Written Responses To Comments on Re-Submittal

Development Engineering Review Page 4

Planner Review 2nd Review Page 5

**5380 Washington St.
Proposed
Sign Conversion**

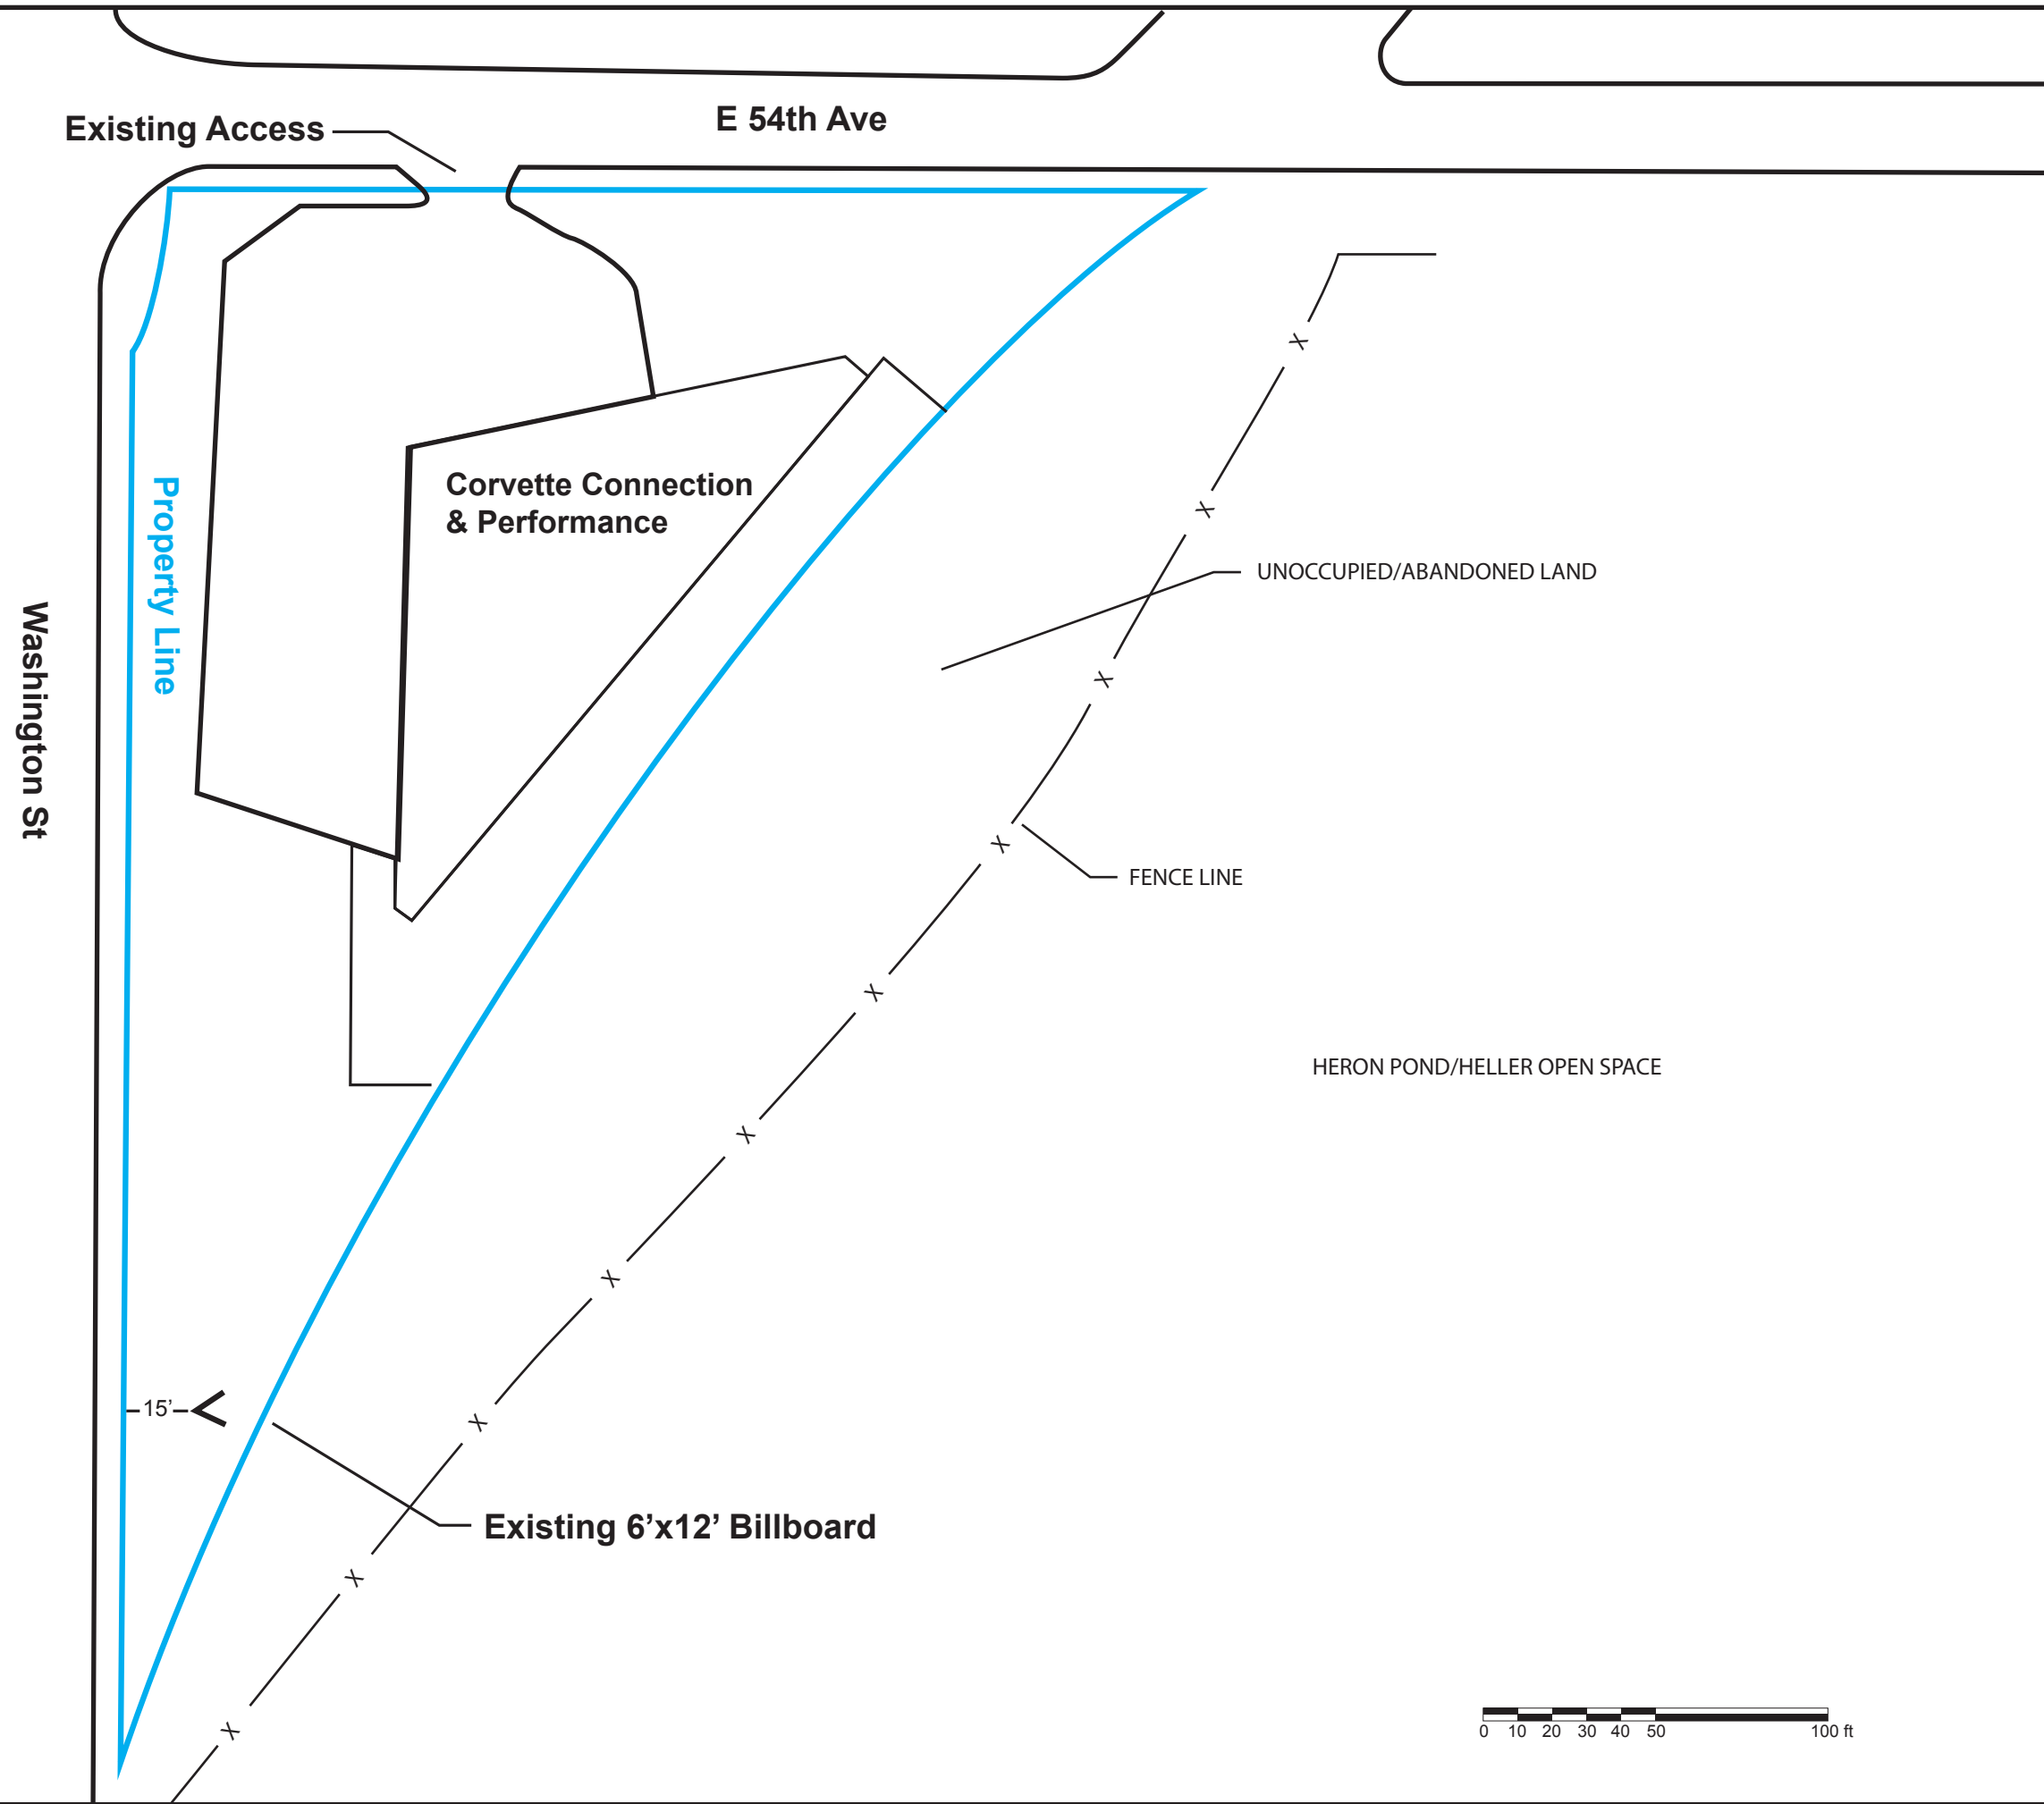
ENG1: A newly rendered site plan shows property boundaries, the location of the proposed improvement (billboard), dimensions of improvement (billboard), North Arrow, and existing access to the site.

ENG2: The new site plan shows a close up demonstrating that the new billboard does not violate any "Minimum Sight Distance Requirements"

ENG3: The new site plan shows distances to all property lines. The property line setback to the east is 15' to the leading edge of the billboard. Mile High outdoor is requesting a 15' variance in this setback to allow for a 30' overall height. This height discourages any unwanted access to the sign. Similar variances have been granted to other outdoor advertising companies, specifically on Parcel #0182515100001, which measures as a 10' setback from the leading edge to the property line. The billboard height is 30' tall.

PLN01: A newly rendered site plan shows the exact footprint of the proposed billboard, along with setbacks to each property line. It is important to note that Mile High outdoor is requesting a 15' variance in this setback to allow for a 30' overall height. This height discourages any unwanted access to the sign. Similar variances have been granted to other outdoor advertising companies, specifically on Parcel #0182515100001, which measures as a 10' setback from the leading edge to the property line. The billboard height is 30' tall.

- PAGE 4 COMMENTS
ENG 1
- PAGE 4 COMMENTS
ENG 2
- PAGE 4 COMMENTS
ENG 3 REQUESTING VARIANCE
- PAGE 2 COMMENTS
PLN 01

New 10'x30' Billboard
Location

5380 Washington St.
Proposed
Sign Conversion

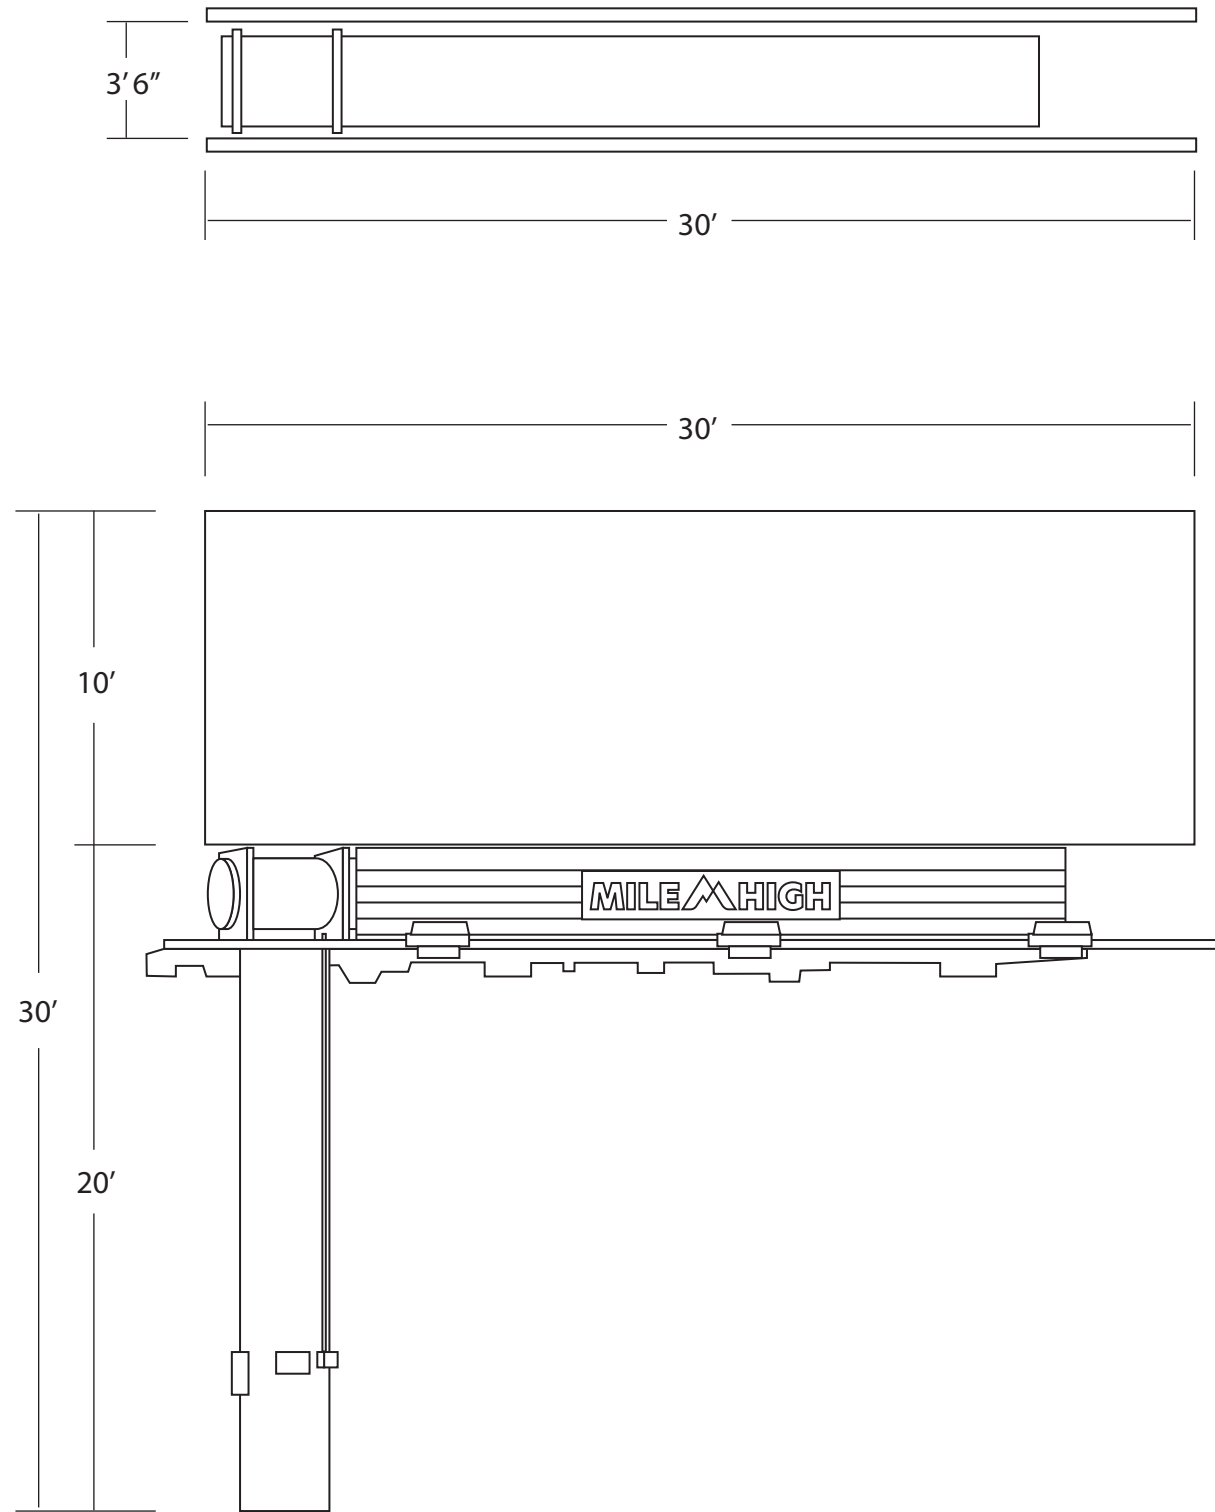
PLN02: The proposed billboard will have two faces that are back to back and will be no more than 3.5' apart. A new elevation plan has been provided for reference.

• PAGE 2 COMMENTS
 PLN 02
